Priority Level: Low — Useful Information		
Attention:	All Service Personnel	Bulletin: SB-032 Date: 2/7/2007
Products:	<i>Need for Speed™</i> Underground	
Issue:	Shifters need adequate slack in micro switch wires.

Shifter Assembly with Broken Micro Switch Wire

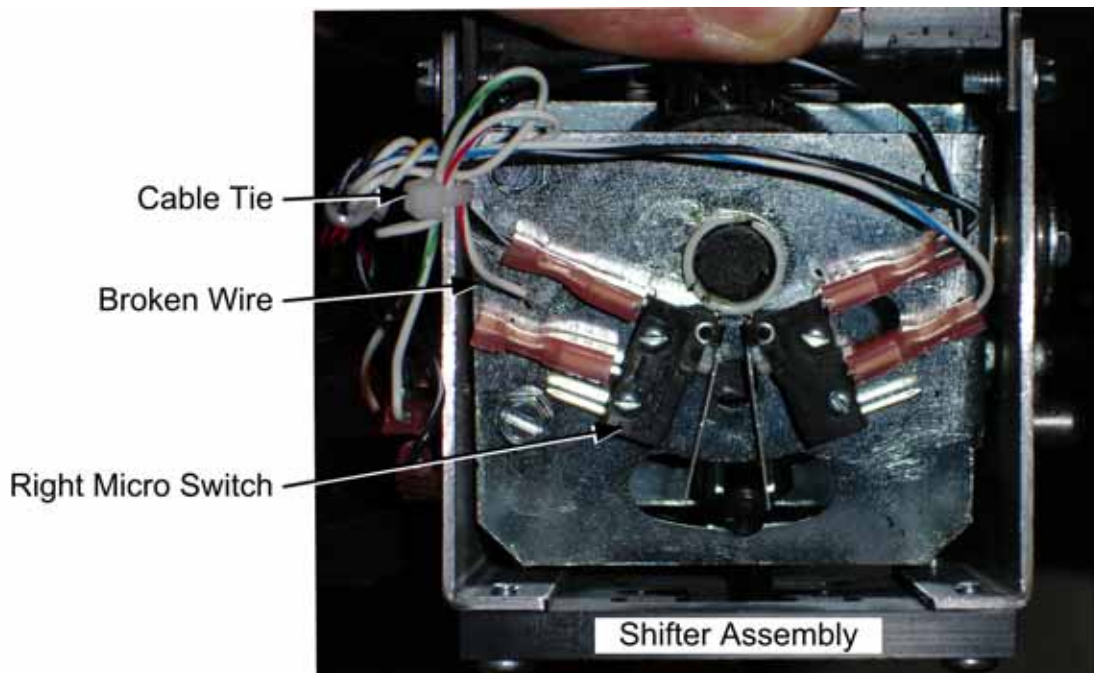
Symptom: Some six-speed shifters were shipped with wires tied too tightly near the micro switches. This can cause the wires to the *Right* micro switch to break, causing the shifter to malfunction in gears 5 and 6.

Solution: Perform the steps below to check the shifter and fix the problem, if found.

1. Remove the four (4) T-10H Torx[®] Security screws from the top of the shifter assembly and carefully lift the shifter assembly out of the housing.
2. Inspect the wires while moving the shifter left to right, and make sure there is some slack in the wires between the cable tie and the switch terminals.
3. If necessary, snip the cable tie and re-tie it so that there is adequate slack in the wire.
4. If the wire has broken, splice it to a new spade connector and make sure there is adequate slack in the wire when you connect it to the micro switch.
